ADDENDUM No. 03

Subject: Wright Elementary School – Major HVAC Renovation
SDP Contract No.

This ADDENDUM dated 1/26/2022 shall modify and become part of the Contract Documents for the work of this project. Any items not mentioned herein, or affected by, shall be performed strictly in accordance with the original documents, unless modified by prior addenda, if any.

DRAWING NO.
EL101
SHEET 66 OF 69

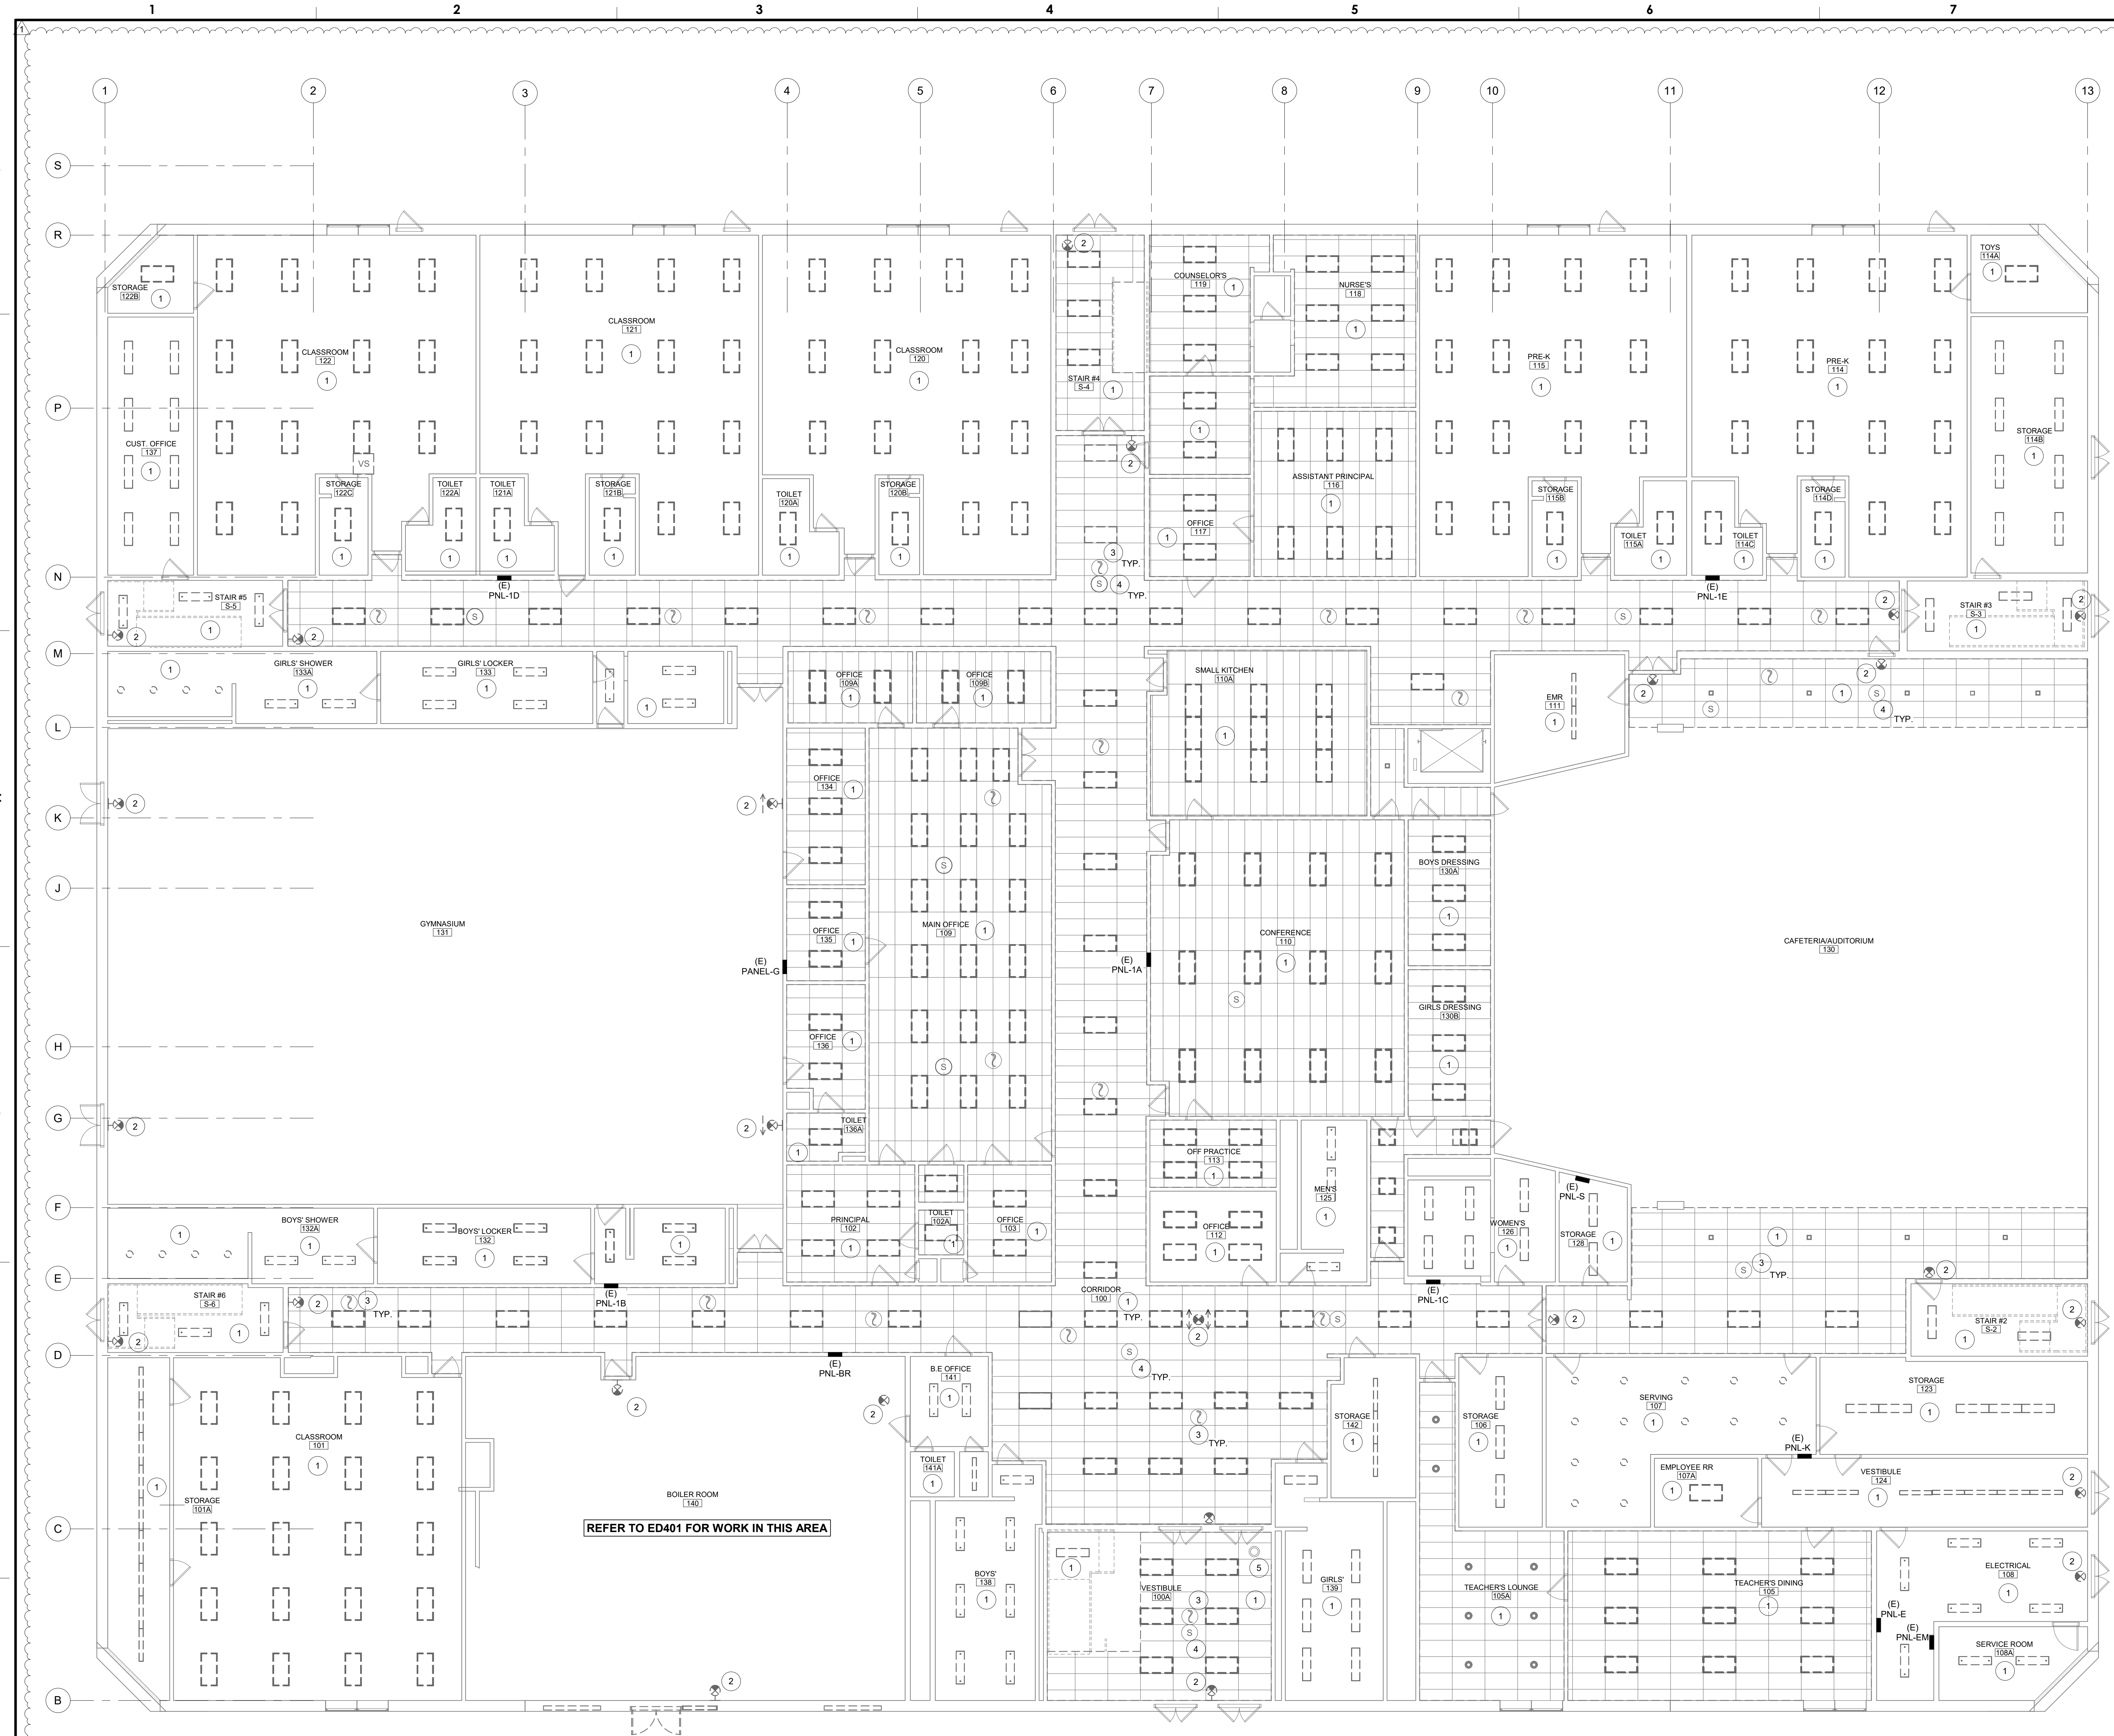
- a) Are we purchasing new light fixtures for these areas
- b) Can you provide a lighting drawing with locations?
- c) Can you provide a model number and any required controls?

Drawing E101, E102 – Keynotes 4&5: Can you provide a drawing showing quantity of light fixtures, fire alarm devices, CCTV, speakers, etc. to be removed and re-installed on new ceilings?

a) The Electrical Contractor shall remove existing lighting and provide new lighting throughout the facility. See attached EL drawings.

- 68 EL103 – Electrical Lighting First Floor New Work
 - 69 EL104 – Electrical Lighting Second Floor New Work
5. ED101
- DELETE references to general lighting scope. This scope has been defined on new drawing EL101.

DRAWING NO.
EL103
SHEET 68 OF 69

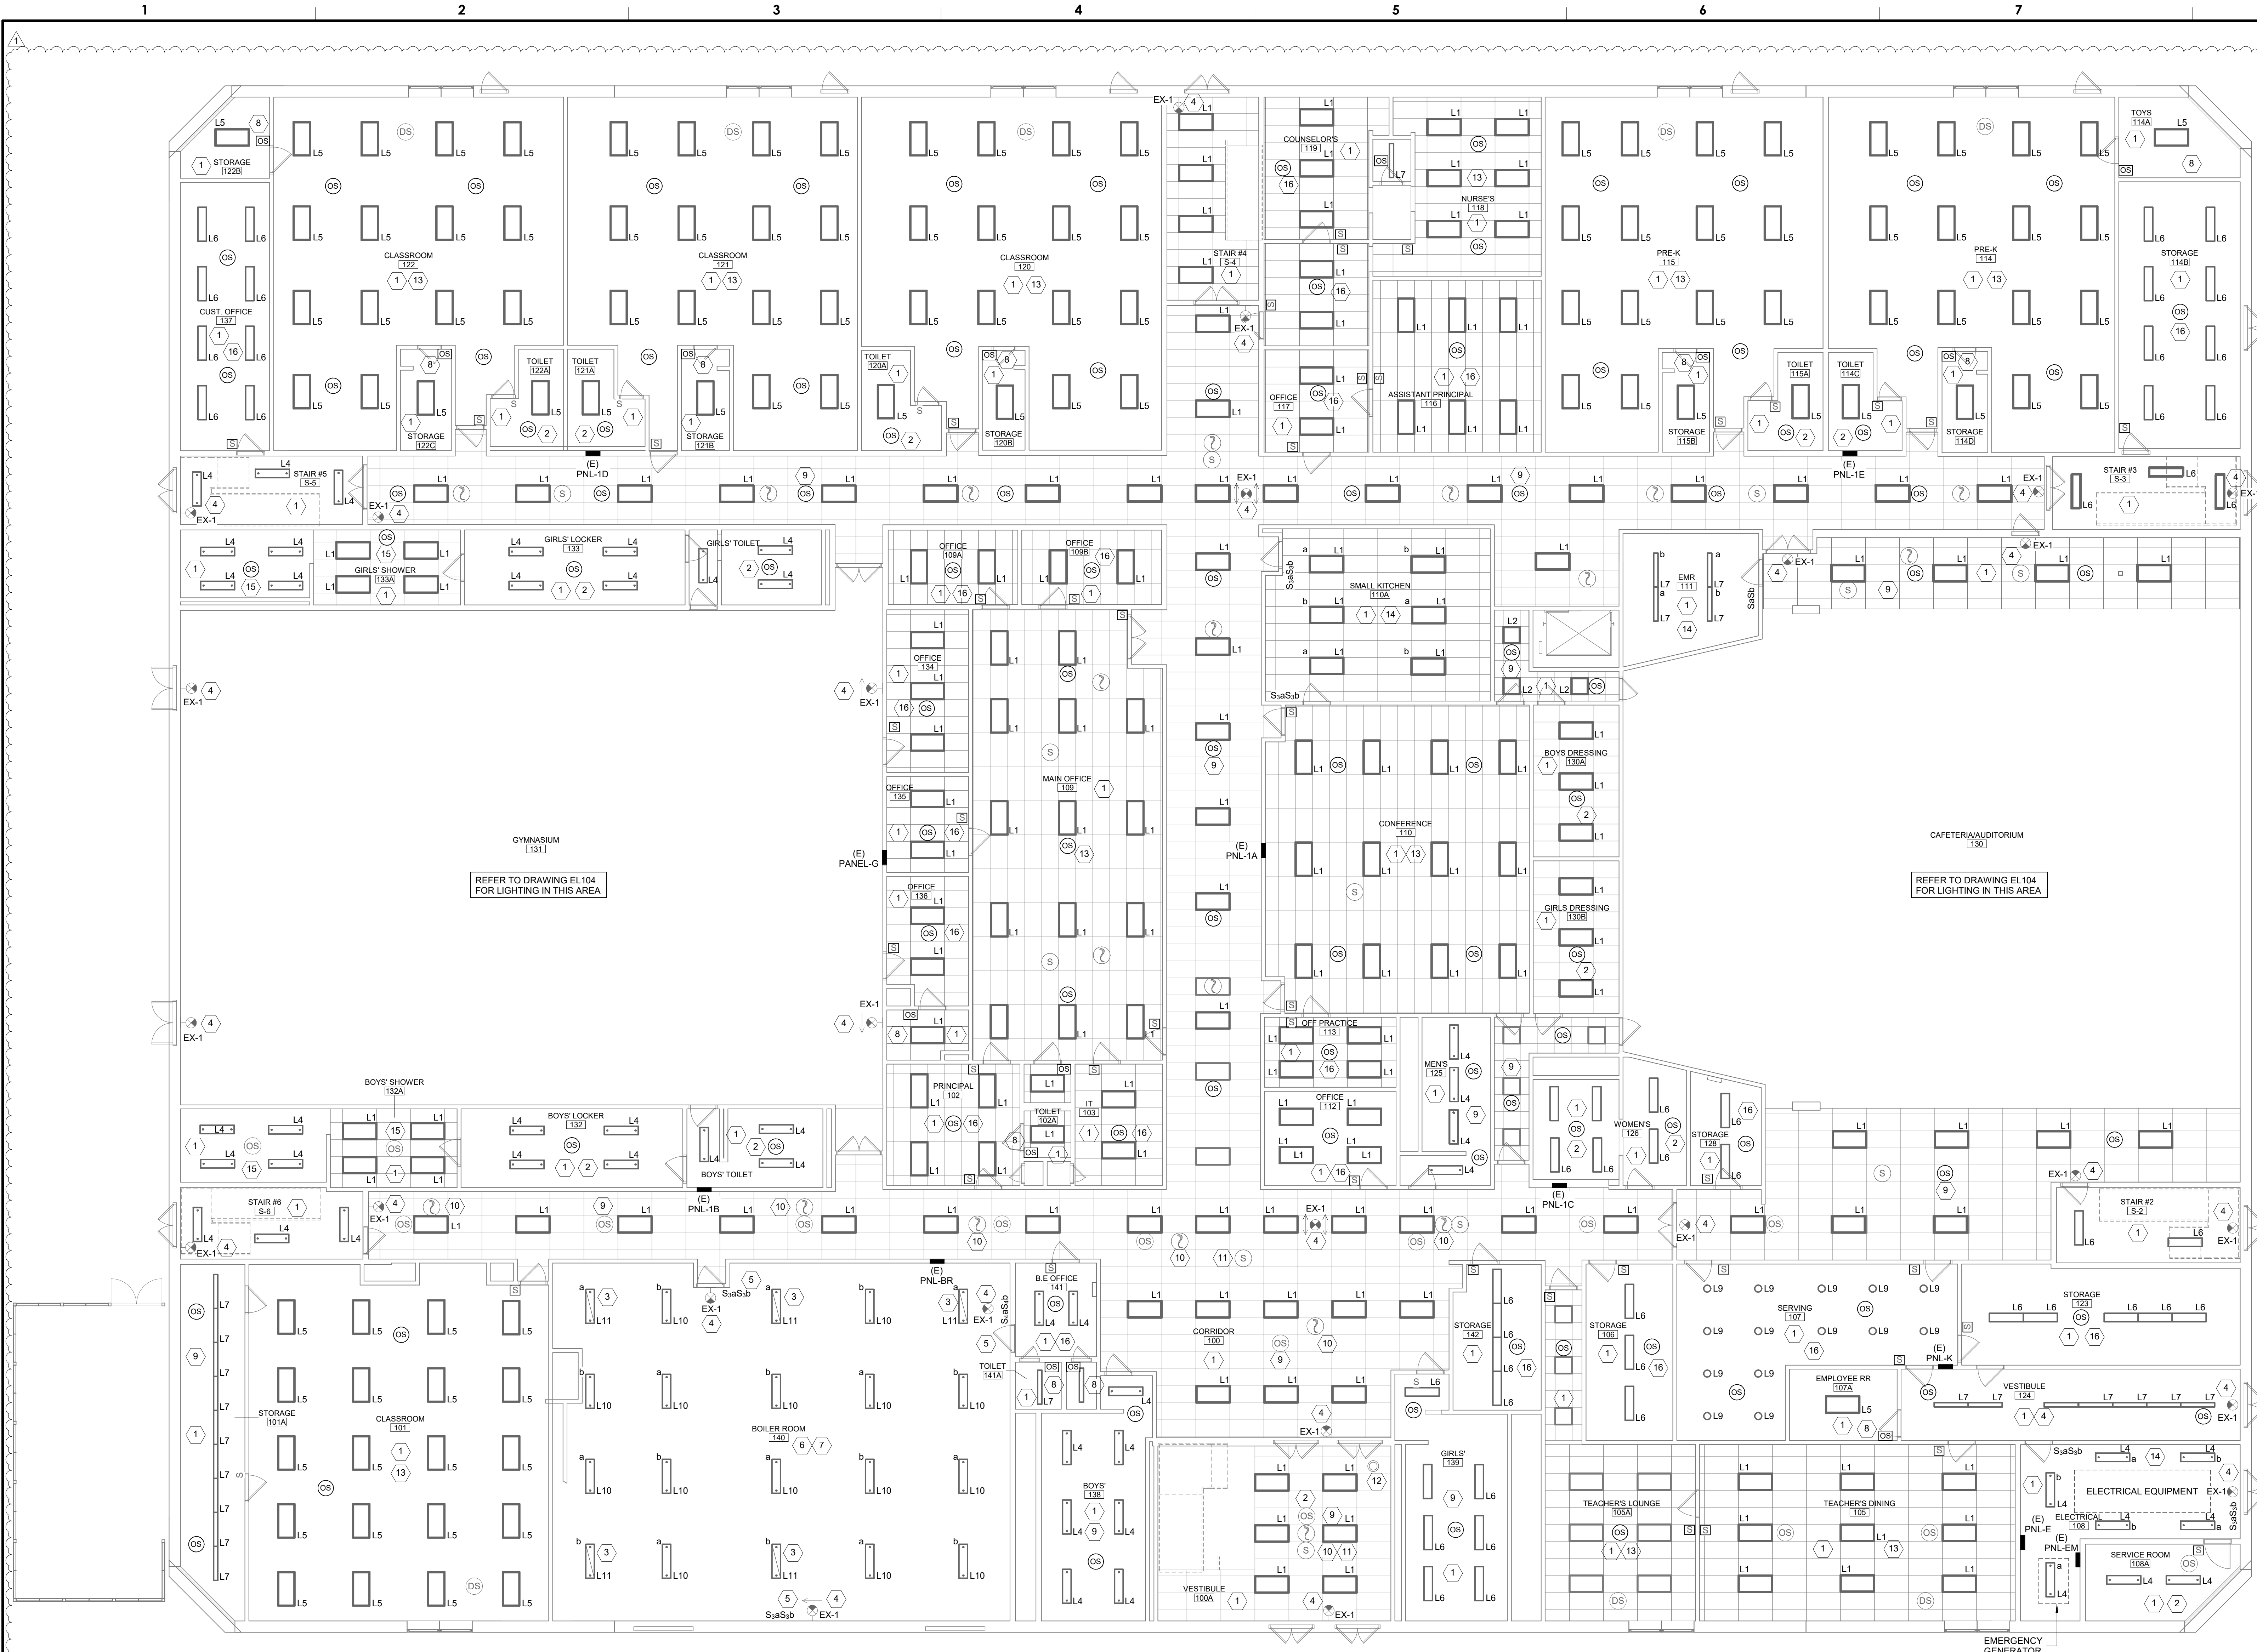
Electrical note 5 on Plans E102 & E103 notes that all Light Fixtures in given rooms will be removed and reinstalled in new drop ceiling. However, when referencing the Architectural RCPs A103 & A104, these notes indicate that the some of the 2x4 lay in fixtures and exit signs are to be replaced with new. Which is correct?

Lighting scope has been amended per new EL Drawings. Electrical Contractor shall remove all existing and provide all new lighting fixtures throughout the building. See attached EL Drawings for new general lighting scope.

6. ED102
- DELETE reference to general lighting scope. This scope has been defined on new drawing EL102.
7. E101
- DELETE references to general lighting scope. This scope has been defined on new drawing EL103.

- Exit Signage scope to remain defined on E102.
9. E401
- DELETE *Electrical New Work Enlarged Boiler Room Plan – Lighting*. This scope has been defined on new drawing EL103.
